Marshall & Winston, Inc. respectfully request permission to plug and abandon the Federal 3 #2. (see attached proposed plug & abandon procedure)

Federal 3 #2  
LEA COUNTY, NEW MEXICO  
API #30-025-25701

INTENT TO PLUG AND ABANDON  
SUNDRY DATED 02/11/19 ATTACHMENT

P&A Wellbore Sketch

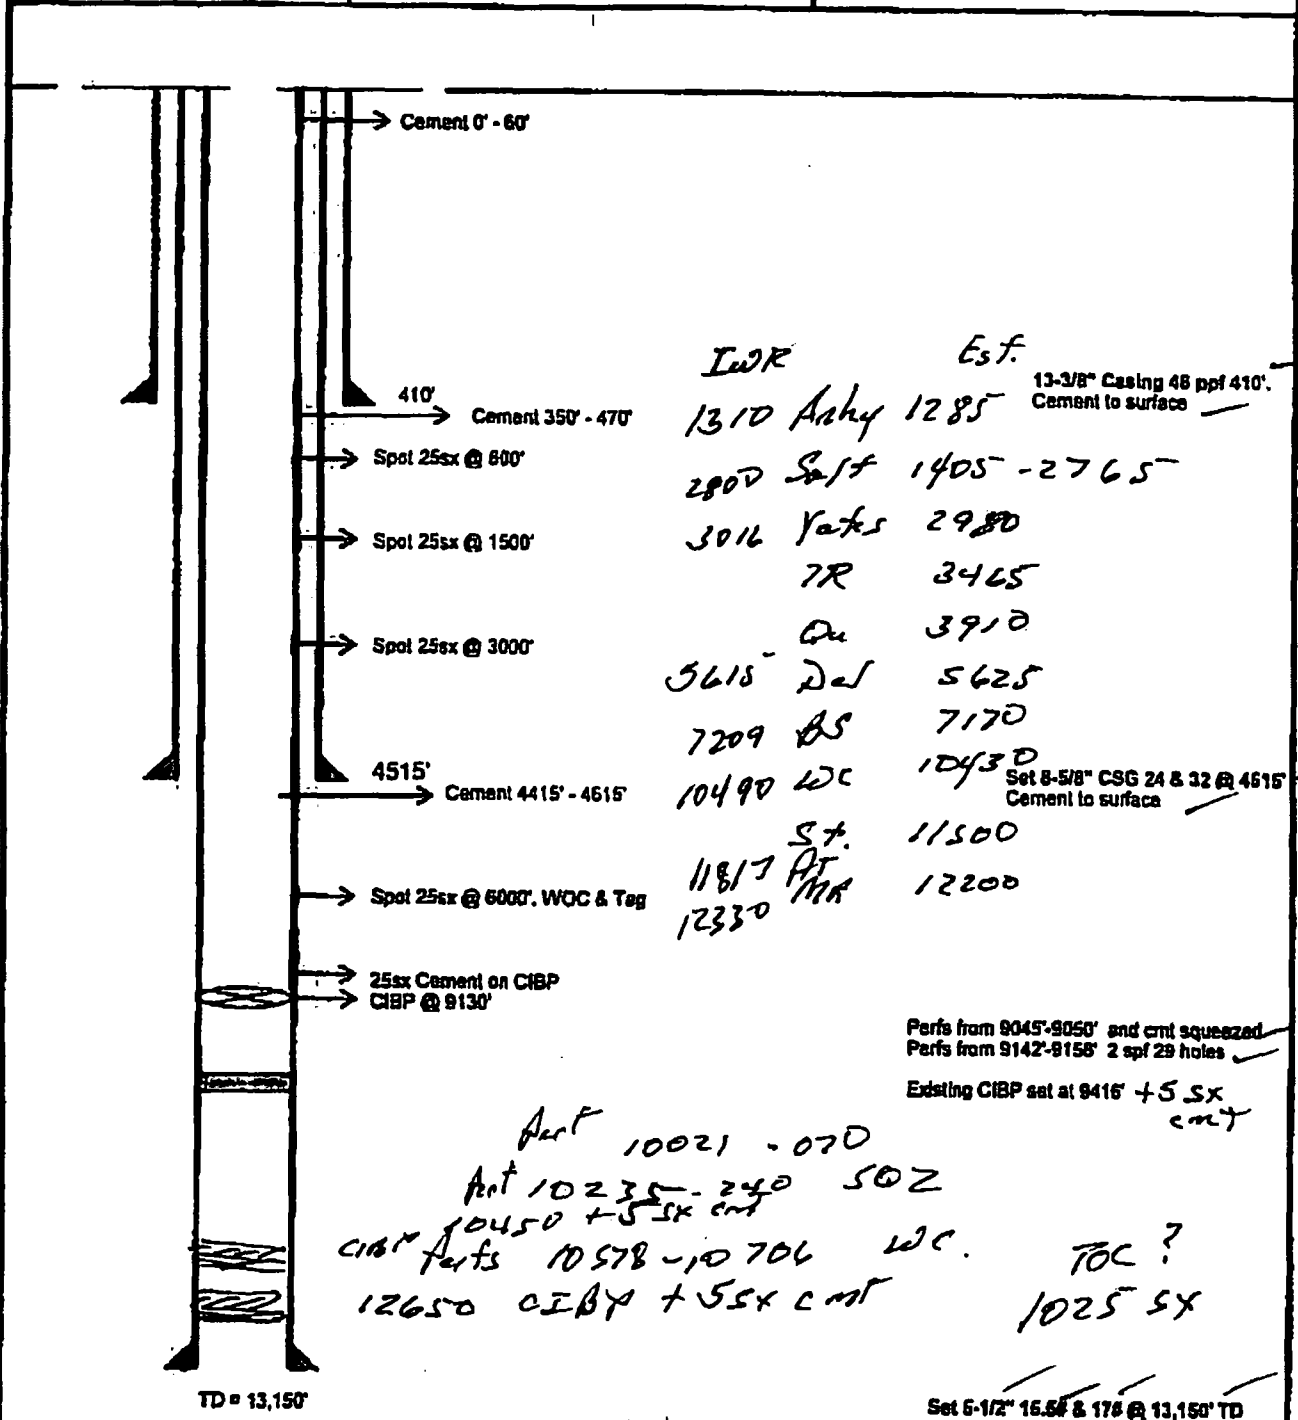
5. Pump 25 sx of cement on plug.
6. Displace w/ 9.0 ppg salt gel based mud.
7. Pressure Test casing to 500 psi. — Add Plug. Start 25 sx 7220 - 7800. (T/Bone, Spring)

- P&S — 8. Spot 25sx @ 6,000'. WOC & TAG 5665 - 5465. (T/De/aware)
9. Pump cement plug from 4615' up to 4415' (Notify NMOCD). Perf 4565, SQZ cnt to 4415' woc Tag (Shoe)

10. Displace w/ 9.0 ppg salt gel based mud.
11. Wait on cement.
12. Tag cement w/ NMOCD official on location. 4415'.
- P&S — 13. Spot 25sx @ 3,000' Perf @ 2850, SQZ cnt to 2730, woc Tag (B/salt)

14. Displace w/ 9.0 ppg salt gel based mud.
- P&S — 15. Spot 25sx @ 1,500' Perf @ 1455, SQZ cnt to 1355, woc Tag T/salt,
16. Displace w/ 9.0 ppg salt gel based mud.

17. Spot 25sx @ 800'
18. Displace w/ 9.0 ppg salt gel based mud.
- P&S — 19. Pump cement from 470' — 360' (Notify NMOCD). Perf 460, SQZ cnt to 360. woc Tag (Shoe)

- P&S — 24. Pump cement from 60' - surface. Perf @ 60', SQZ cnt to surf.
25. Cut off wellhead 3' below surface.
26. Cap well with 1/2" steel plate.
27. Well marker on plate, no more than 4' above ground w/ well name, operator, legal location and plug & abandon date.

Below ground level dry hole marker required. LAC Habitat.
